VXI-5538 Errata

These changes update the December 1996 Edition of the VXI-5538 Manual, Revision X2.

Figure 3-5 VXI-5538's 488.2 Status Reporting Structure

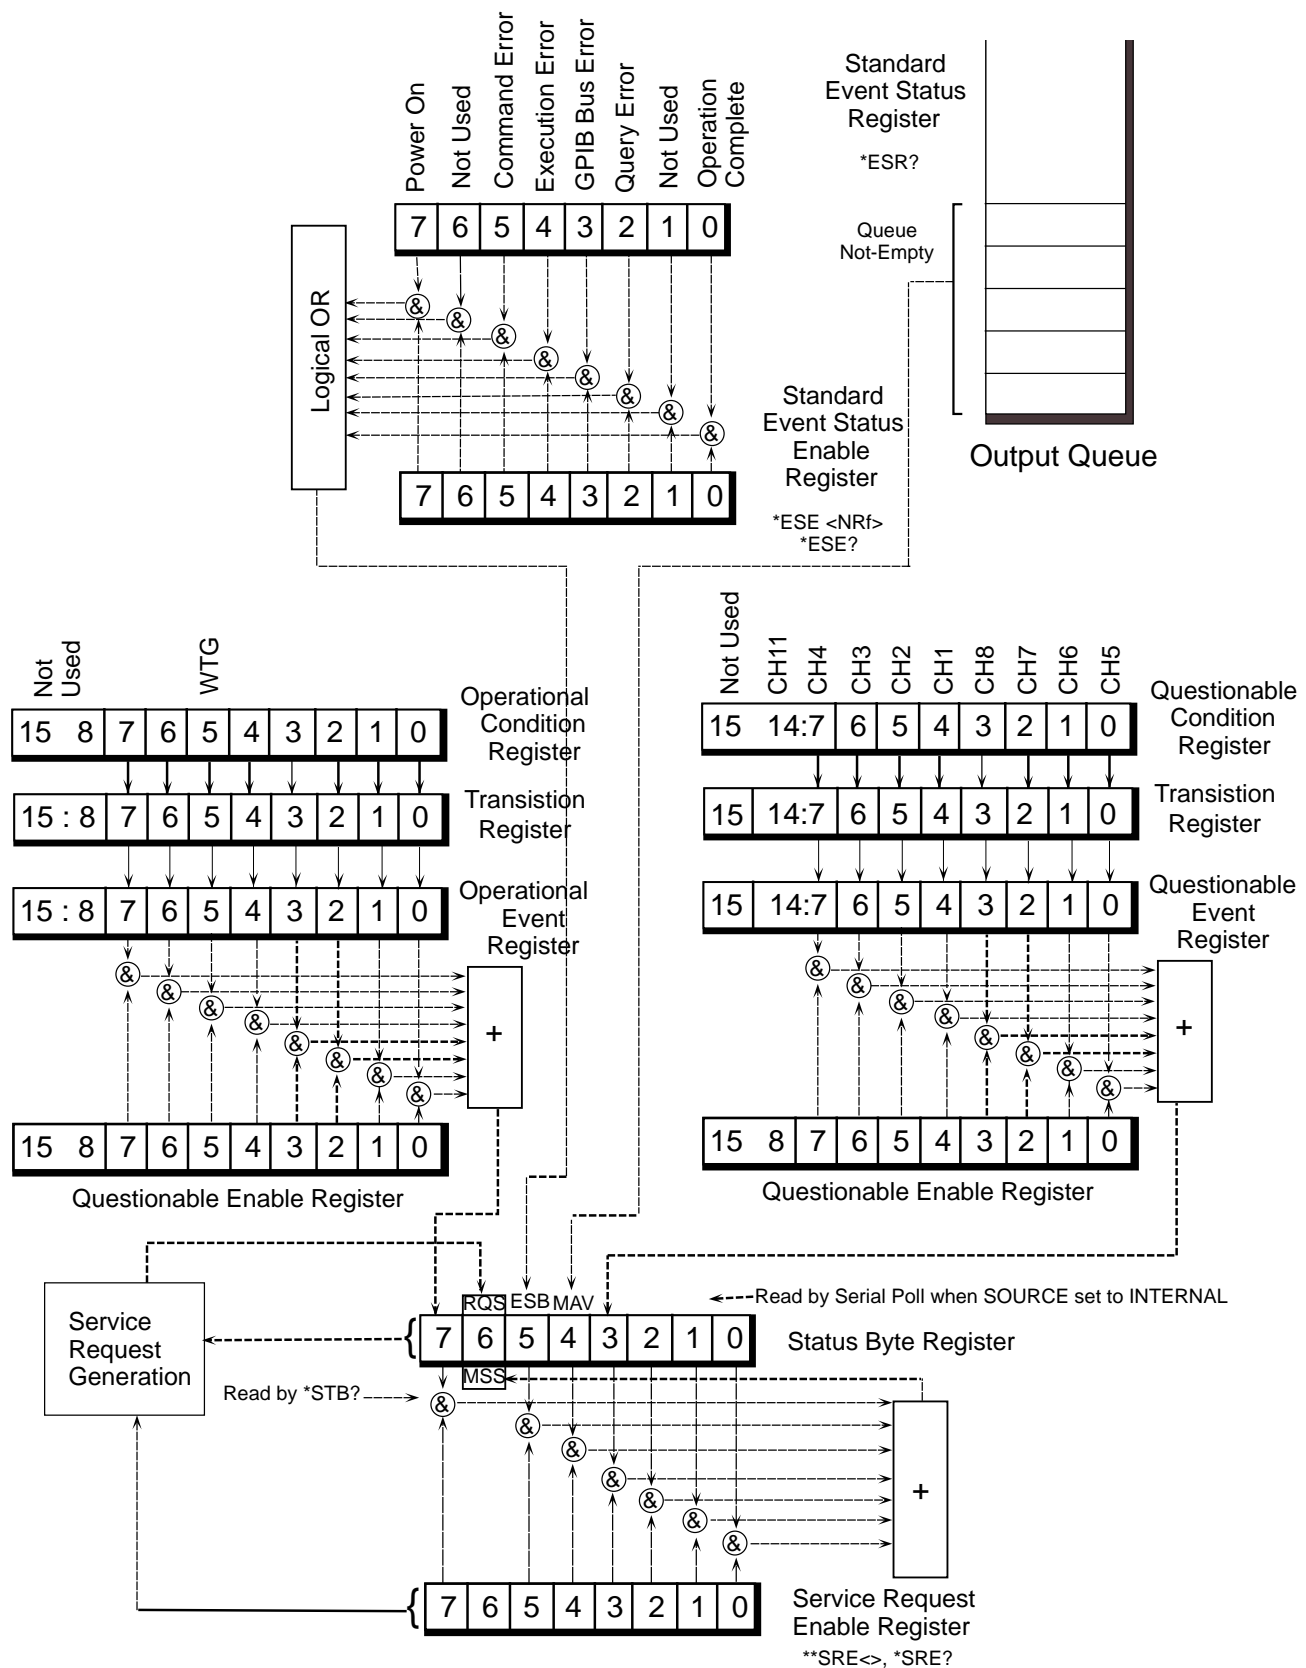
E.1 IEEE-488.2 STATUS STRUCTURE CHANGE

Figure 3-5 revised to show ESR Bit 3 as the GPIB Bus Error bit.

Note: ESR Bit 3 is a Device Dependent bit. The VXI-5538 uses this bit for GPIB Bus Errors.
